Refer to: HSA-10/WZ-118

Thank you for your letter of March 11, 2002, requesting Federal Highway Administration (FHWA) acceptance of your company's channelizing devices as crashworthy traffic control devices for use in work zones on the National Highway System (NHS). Accompanying your letter was product literature for these items. You requested that we find the TD6000 VIP Vertical Indicator Panel and the TD6000 Ringtop Delineator Post and Ringtop Stackable Cone acceptable for use on the NHS under the provisions of National Cooperative Highway Research Program (NCHRP) Report 350 "Recommended Procedures for the Safety Performance Evaluation of Highway Features." You also requested a modification to your company's Type III barricade design that was originally found acceptable in our letter WZ-82 of September 14, 2001. Action on the barricade was handled in Acceptance Letter WZ-128 dated July 12, 2002.

VIPtm
VERTICAL INDICATOR PANEL
TD6000 SERIES
SPECIFICATIONS

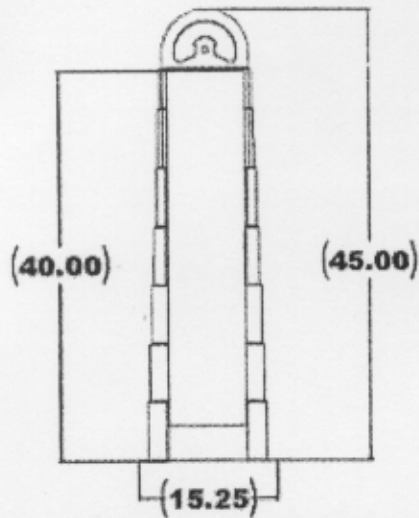
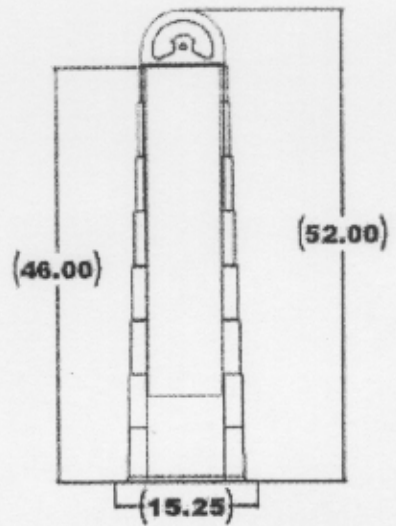
The **TD6000 VIP Vertical Indicator Panel** is a Category 2 work zone traffic control device. It is molded of Low Density Polyethylene and is available in two heights, 45 inches and 52 inches.

The weight of the 45 inch VIP is 5.5 pounds. Either may be ballasted with recycled rubber bases weighing 10, 20, or 30 pounds. The highest of these bases has a profile of 3.5 inches above the pavement.

The VIP Vertical Indicator Panel with rubber base is similar to a number of other vertical panel and cone devices. We concur in your contention that it may be considered crashworthy with no additional testing and, therefore, the devices described above and shown in the enclosed drawings for reference are acceptable for use on the NHS under the range of conditions similar models were tested, when proposed by a State.
